EVALUATION OF RESPONSE TO UNSATISFACTORY VERIFICATION OF CORRECTIVE ACTION  
REQUEST (CAR) YM-92-073 RESULTING FROM YUCCA MOUNTAIN QUALITY ASSURANCE  
DIVISION (YMQAD) AUDIT YMP-92-22

**CORRECTIVE ACTION REQUEST**

**RESPONSE TO ISSUANCE OF CORRECTIVE ACTION REQUEST (CAR) YM-092-073 RESULTING  
FROM YUCCA MOUNTAIN QUALITY ASSURANCE DIVISION AUDIT YMP-92-22 OF SANDIA  
NATIONAL LABORATORIES**

FIGURE 1. RELATIONSHIP OF STRATIGRAPHY, LITHOLOGY AND HYDROSTRATIGRAPHIC ZONES AT G-4  
(Adapted from SNL [1991], Figure 3-5)

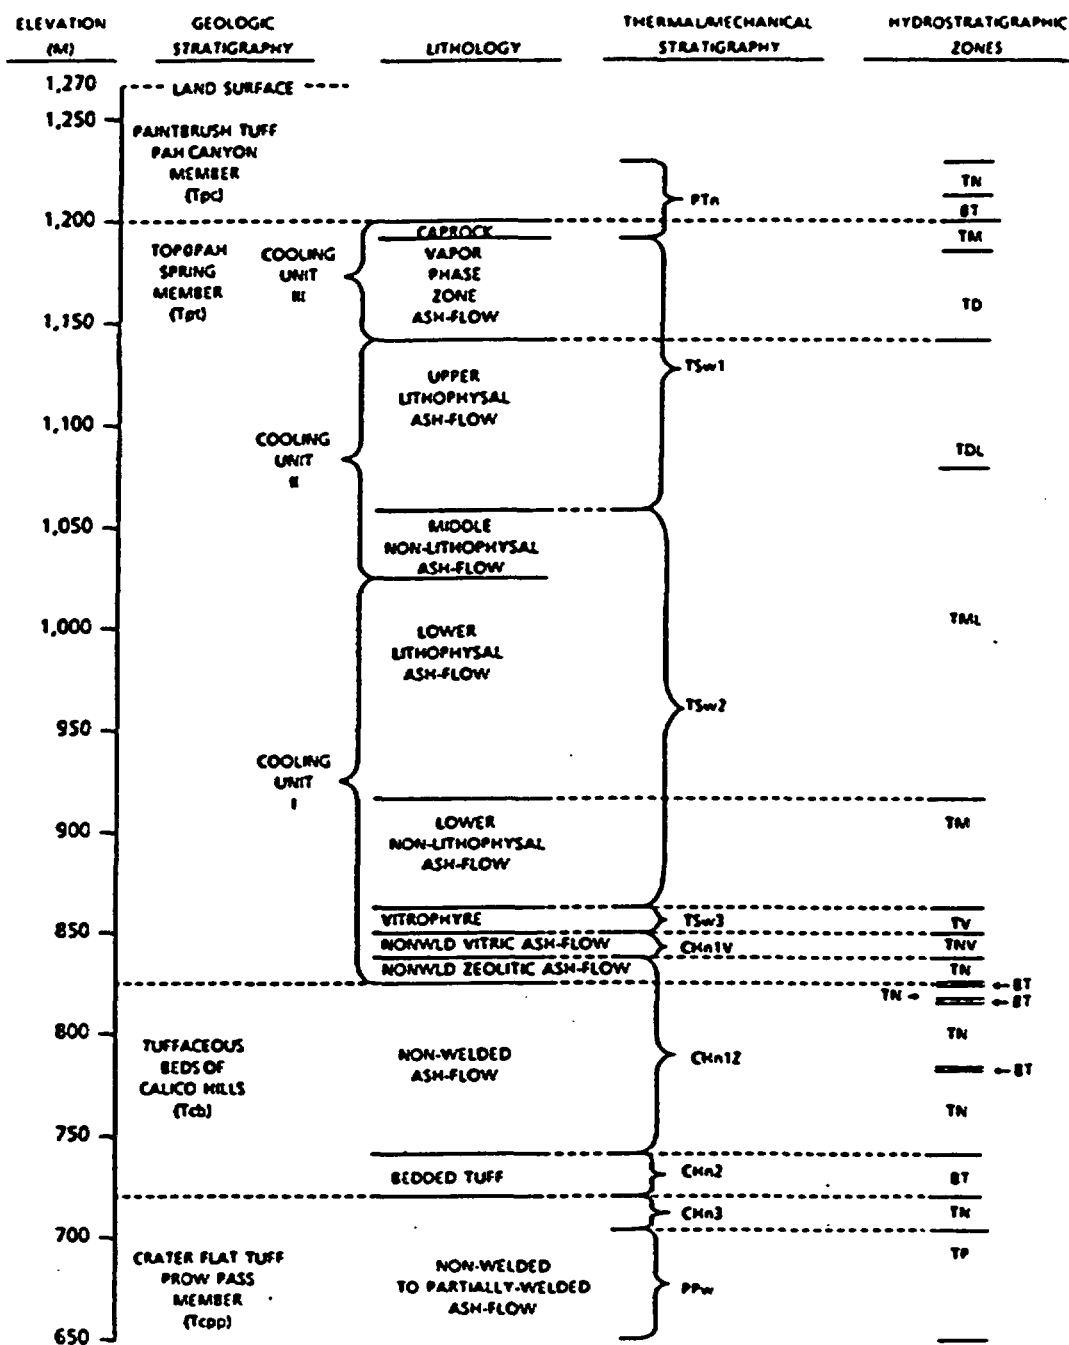
1 Controlling Document QARD, Revision 4		2 Related Report No. Audit YMP-92-22	
3 Responsible Organization YMP		4 Discussed With A. Simmons	
5 Requirement: The QARD, Revision 4, Appendix A, Paragraph 20.1.B.6 states planning measures include: "The evaluation of data quality to assure that generated data is valid, comparable, complete representative, precise and accurate."			
6 Adverse Condition: The Reference Information Base (RIB), Version 4, Revision 6, contains different values for Thermal/Mechanical Stratigraphy data for Borehole USW G-4. Stratigraphy depths found in Table 1 "Thermal/Mechanical Stratigraphy for Borehole USW G-4" (found in chapter 1, section 1, item 2, page 2 of 3) does not agree with the "Thermal/Mechanical Stratigraphy" values in Figure 1 "Relationship of Stratigraphy, Lithology and Hydrostatic Zones at G-4" (found in chapter 1, section 4, item 4, page 3 of 6) in all cases.

Although no QA requirement has been breached, it is recognized that there is a potential for misuse of information presented in Figure 1 of Item 1.4.4. I appreciate the fact that the audit results pointed this out. Steps will be taken, in accordance with Yucca Mountain Site Characterization Project Administrative Procedure 5.3Q, to rectify the problem.

- A. Remedial Action - Delete RIB Item 1.4.4 Hydrogeologic Zones. This action removes the apparent inconsistency described in the CAR.
- B. Investigative Action - Principal Investigators at SNL reviewed the information contained in Items 1.1.2 and 1.4.4 of the RIB. The conclusion of the review was that a more detailed technical assessment was necessary to recommend changing either Item. Because the RIB contains the best available data at a given point in time, it was determined that the best available Stratigraphic Data is contained in RIB Item 1.1.2 which has more utility at this time than RIB Item 1.4.4. Therefore, to eliminate an apparent inconsistency, RIB Item 1.4.4 will be removed. Updated hydrogeologic data will replace the current information as it becomes available.
